SB-10056995-7378 Service Bulletin

Bulletin No.: P11307

Subject: Malfunction Indicator Lamp (MIL) Illumination with DTC P0171: Fuel Trim System Lean

Models: 2012-2014 Chevrolet Sonic
Condition/Concern

3976038

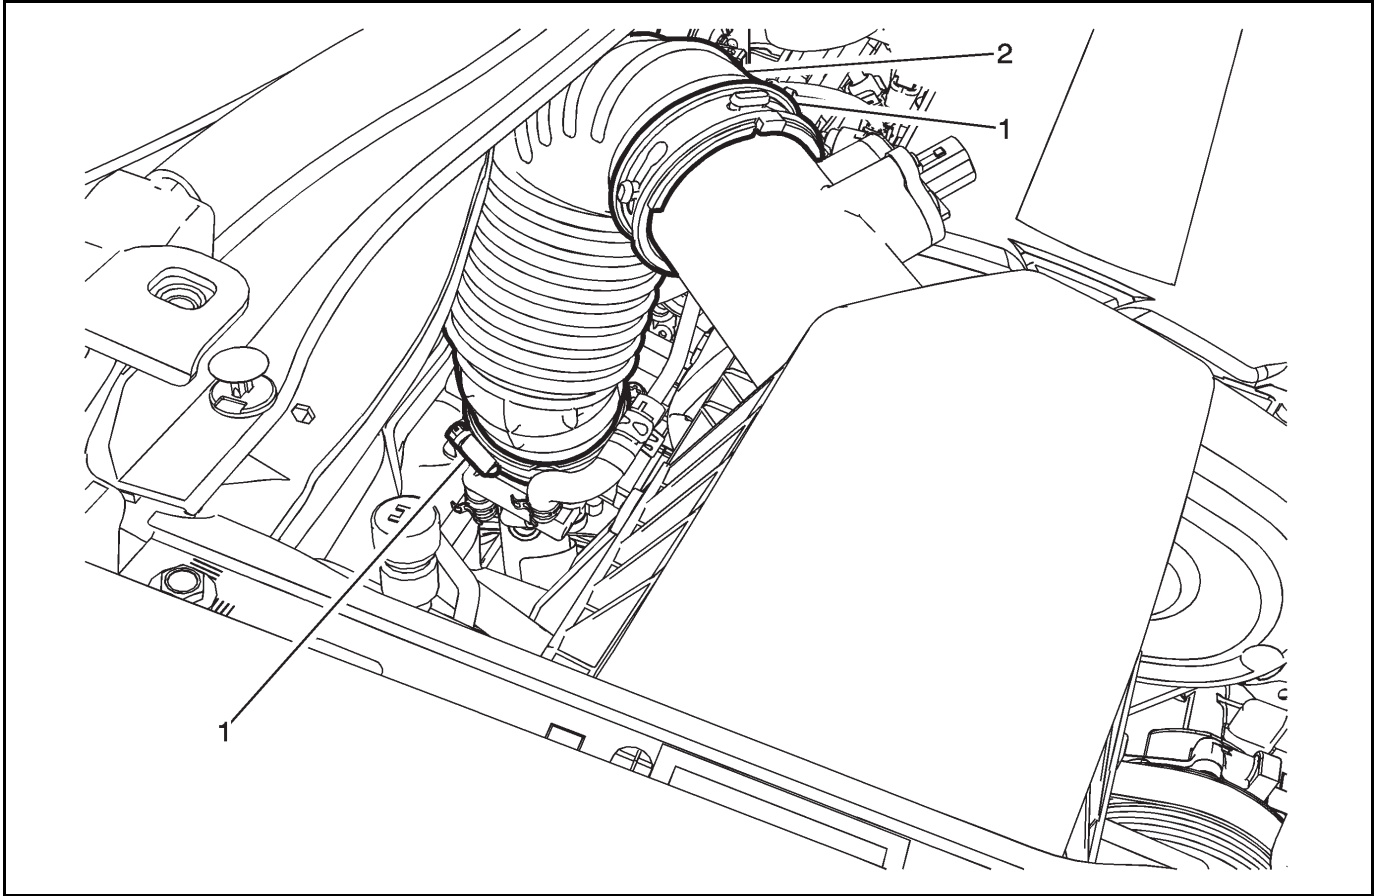
This may be due to the air cleaner outlet duct, located after the mass air flow (MAF) sensor, having splits allowing improper airflow into the induction system.

In the example above are splits that can be present.

1. Inspect for splits as shown in the example above. If splits are detected, proceed to the following step.
2. Loosen the clamp (1) that secures the duct (2) to air cleaner assembly.
3. Loosen the clamp (1) that secures the duct (2) to the throttle body assembly or turbocharger.
4. Replace the outlet duct with the service part listed below.
5. Secure the clamps on the new duct.
6. Clear DTCs and reset fuel trim if applicable.
